<b>JRPP No:</b>	<b>2010SYE057</b>
<b>DA No:</b>	<b>DA10/0720</b>
<b>PROPOSED DEVELOPMENT:</b>	Proposal: <b>Commercial Development - Demolition of Existing Structures and Construction of a Four (4) Storey Commercial Building</b> Property: <b>Lot 18 DP 8461, Lot 19 DP 8461 &amp; Lot 1 DP 21256 (Nos. 531-533) Kingsway MIRANDA</b>
<b>APPLICANT:</b>	<b>Adrian Tripodina</b>
<b>REPORT BY:</b>	Carolyn Howell Environmental Assessment Officer (Planner) Sutherland Shire Council Phone: 9710.0841

## Assessment Report and Recommendation

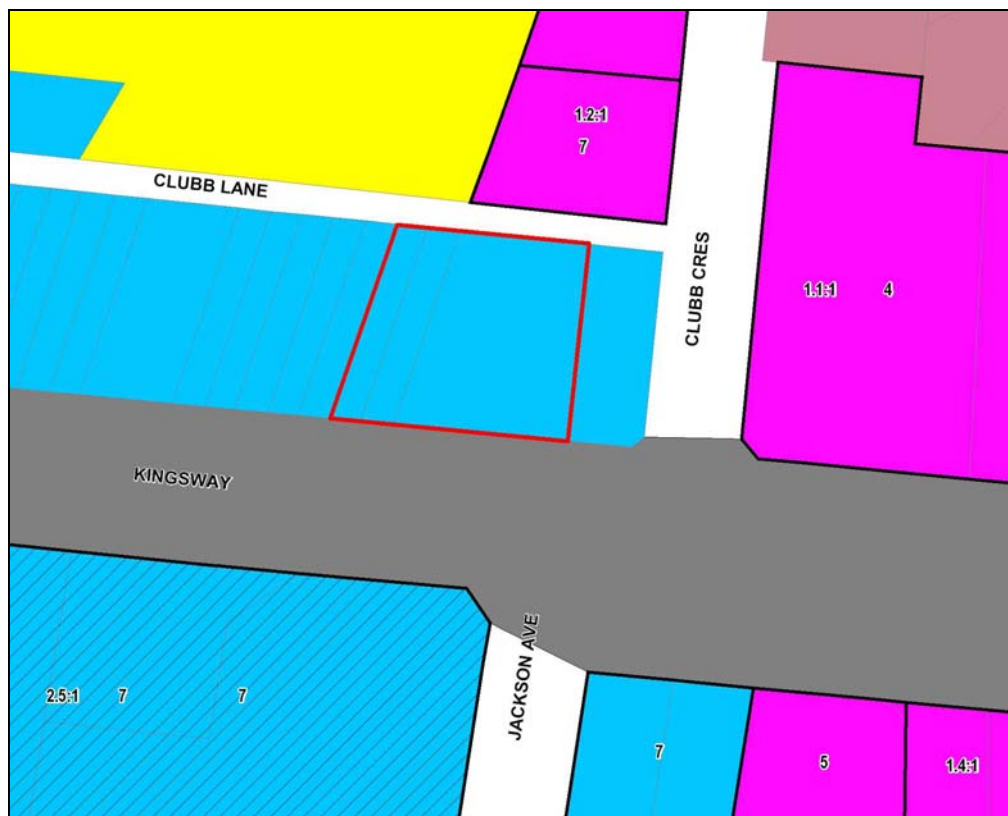
Analysis: The subject site is located one property west of the eastern edge of the north-eastern perimeter of the Miranda Commercial Centre. The portion of the Miranda Commercial Centre fronting Kingsway between Kiora Road and Clubb Crescent has a height limit of three (3) storeys. Some other portions of the Miranda Commercial Centre have height limits in the order of seven (7) storeys. The applicant's proposed variation relies on the height controls applying to surrounding precincts and purports that this portion of the Miranda Commercial Centre has been given an inappropriate height control.

The below extract from the height and density maps contained within SSLEP 2006 demonstrates that the subject site does not benefit from the provisions of this clause.
